# Accessibility Survey

# City of Downey Neo Street - Old River School Drive To End

Date of Inspection 4/24/2017

Prepared By Disability Access Consultants (800) 743-7067

#### Change In Level West Of Haro Avenue @ 33.946158006182, -118.152945935726

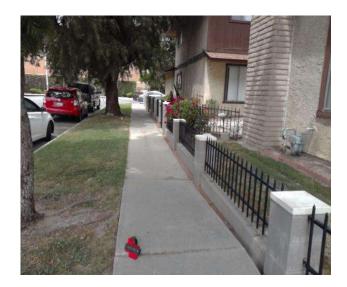
There is a change in elevation greater than recommended value.

**On-Site Finding** 1.25 inches

Ensure that the change in elevation is within the recommended value.

Recommendation Up to 0.25 inches

#### Change In Level West Of Haro Avenue @ 33.946165793894, -118.152970075607

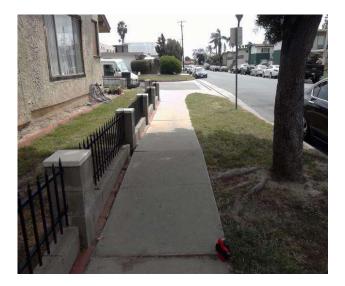
There is a change in elevation greater than recommended value.

**On-Site Finding** 1.00 inches

Ensure that the change in elevation is within the recommended value.

Recommendation Up to 0.25 inches

#### Change In Level West Of Haro Avenue @ 33.946225870501, -118.153093457222

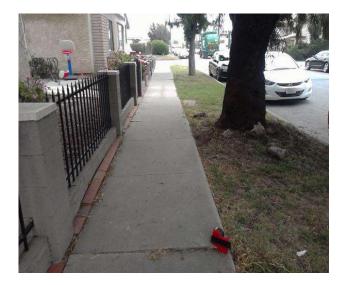
There is a change in elevation greater than recommended value.

**On-Site Finding** 1.12 inches

Ensure that the change in elevation is within the recommended value.

Recommendation Up to 0.25 inches

#### Curb Northwest Corner Of Adco Avenue @ 33.945530536800, -118.151811361313

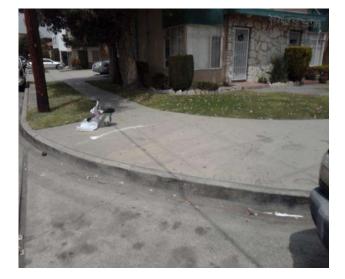
There is a curb on the designated path of travel.

**On-Site Finding** Not Compliant

Provide a compliant curb ramp.

# Driveway West Of Adco Avenue @ 33.945664041311, -118.152055442333

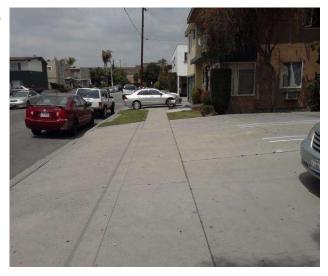
Cross slope at vehicular traffic is not compliant.

On-Site Finding 3.30 percent

Repave the surface to provide a compliant cross slope.

Recommendation Up to 2.08 percent

#### Sidewalk West Of Haro Avenue @ 33.946131305452, -118.152912408113

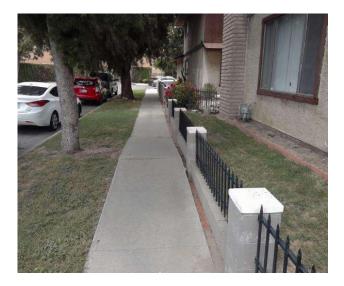
Sidewalk cross slope is not compliant.

**On-Site Finding** 4.40 percent for 8.00 feet

Repave the sidewalk surface with the recommended cross slope.

Recommendation Up to 2.08 percent

#### Sidewalk West Of Haro Avenue @ 33.946131305452, -118.152912408113

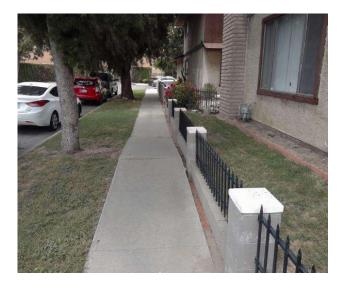
Sidewalk running slope is not compliant.

**On-Site Finding** 6.70 percent for 20.00 feet

Repave the sidewalk surface with the recommended running slope.

Recommendation Up to 5.00 percent

#### Sidewalk West Of Haro Avenue @ 33.946192494613, -118.153038471937

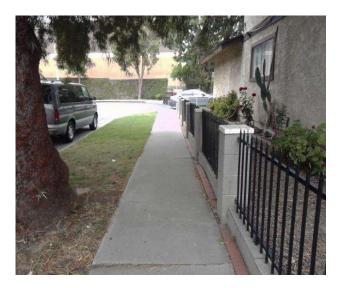
Sidewalk cross slope is not compliant.

**On-Site Finding** 3.80 percent for 12.00 feet

Repave the sidewalk surface with the recommended cross slope.

Recommendation Up to 2.08 percent

# Northeast Corner Of Old River School Drive @ 33.944995404116, - 118.150767982006

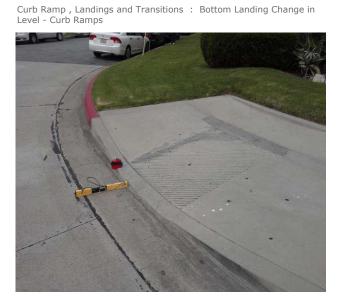
The transition from the bottom of the curb ramp to the walk, gutter, or street is abrupt.

**On-Site Finding** Not Beveled

Patch the transition area at the bottom of the curb ramp so that the transition is flush and free of abrupt changes.
